**0006** Technical Service Information

Concerns:	61-28975-20
Make:	Mercedes Benz
Model:	6-cylinder M 104 series engines
Engine code:	M104.941-945 / 980 / 981 / 990-996

**CHG metal reinforcement
Mercedes Benz M 104**

Fig. 1_Old version, 61-28975-20

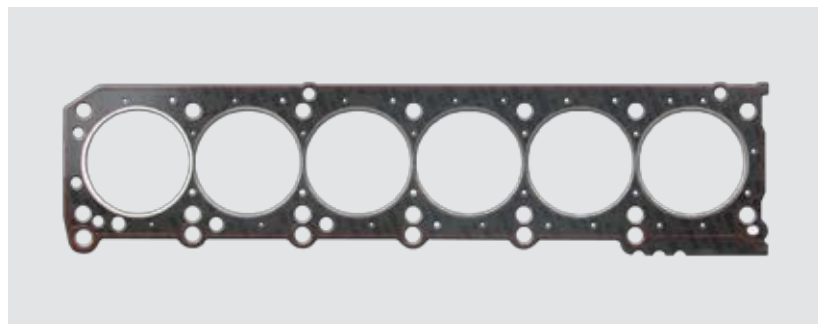
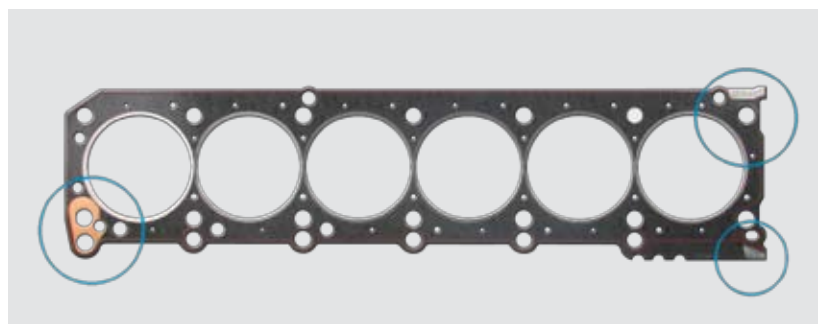
The cylinder head gasket 61-28975-20 has been replaced by 61-28975-30. In this new version, additional metal reinforcements have been added to improve durability, particularly in high-performance engines.
